P.O.A.D.P. & P.U.D. PLAN

THE RESERVE AT WESTOVER HILLS

Re: Reserve at Westover Hills

POADP # 622

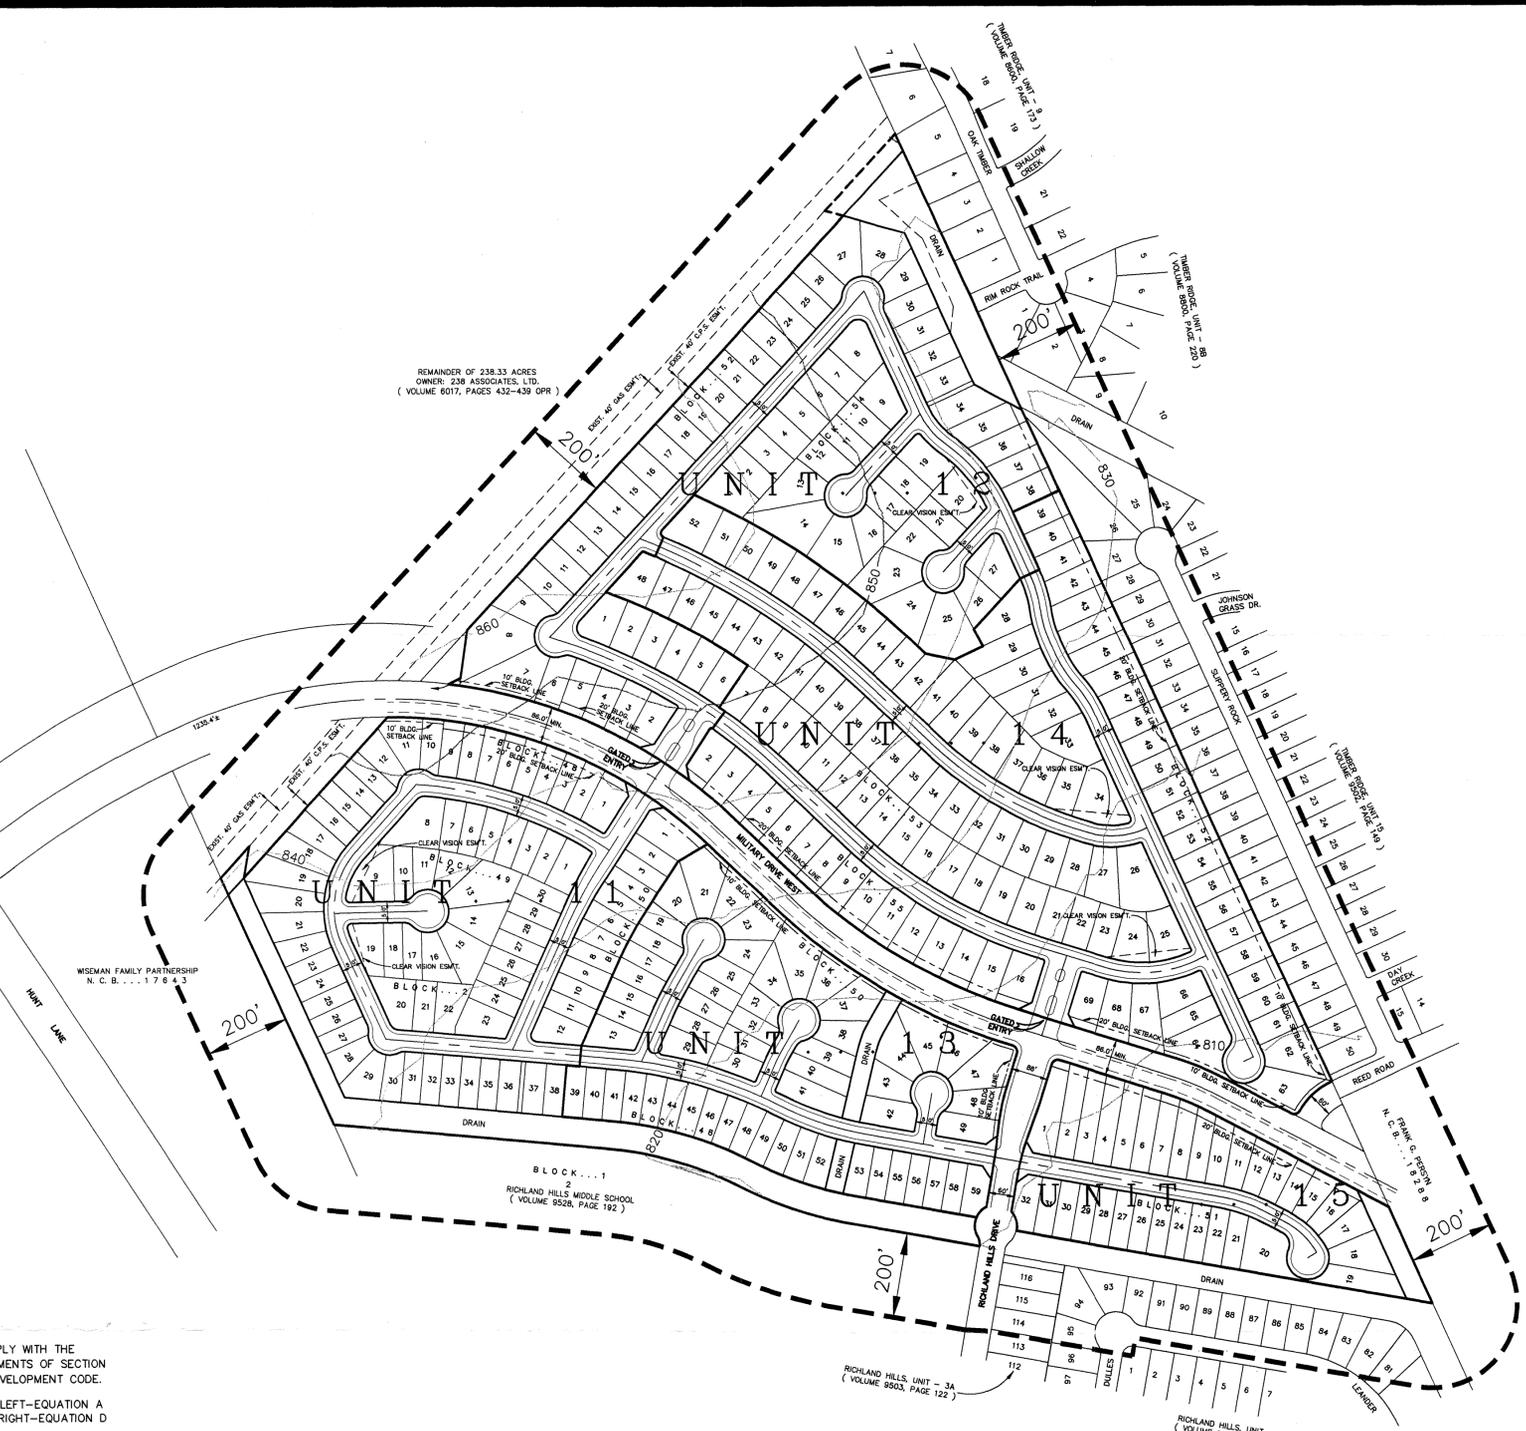
The City Staff Development Review Committee has reviewed Reserve at Westover Hills Subdivision Preliminary Overall Area Development Plan # 622. Please find enclosed a signed copy for your files. Although the southern portion (area south of Military Drive West) of your plan was accepted, please note the following:

- Based on the topography, a Flood Plain Study and drainage review will probably be required during the platting process.
- This development will need to comply with tree preservation ordinance #85262. For information about these requirements you can contact Building Inspections at 207-7102.
- It will be expected that you will plat all of the property depicted in your POADP, to include: floodpains, drainage areas and open space.
- I would encourage you to work closely with the school district, so that they can plan accordingly.

The documents submitted to the Planning Department for the Reserve of Westover Hills # 622 does not meet the requirements for acceptance for consideration of giving Preliminary Overall Area Development Plan (POADP) status.

- Section 35-4102 of the Unified Development Code (UDC) states that "Where necessary to the neighborhood pattern existing streets in adjoining areas shall be continued and shall be at least as wide as such existing streets and in alignment therewith." By interpretation you will need to connect the sub-street that are located at Rim Rock Trail and Reed Road.

Continental Homes, purchased an 83 acre tract of land, that is a portion of the approved P.O.A.D.P. #418 "The Reserve at Westover Hills Planned Unit Development". This P.O.A.D.P. was approved on 8/26/94 and the Planned Unit Development Plan subsequently followed. Please find attached copies of the appropriate areas of concern on P.O.A.D.P. #418.

Continental submitted nonsubstantial amendments to the 83 acre portion of the P.U.D. plan to Planning on November 25, 1998. The primary amendment was to add a second ingress/egress to Military Drive West for the northern Unit 12 and Unit 14, which required internal street circulation changes.

We were told verbally that the submitted P.O.A.D.P. was denied due to not extending Rim Rock Trail into the proposed Unit 12. The owner is confused as Rim Rock Trail was not extended on the approved P.O.A.D.P. #418 and associated P.U.D. Plan. Extending Rim Rock through a gated community would not be conducive with the private streets. Reed Road appears to be the planned collector that ties Culebra Road and the soon to be completed Military Drive West.
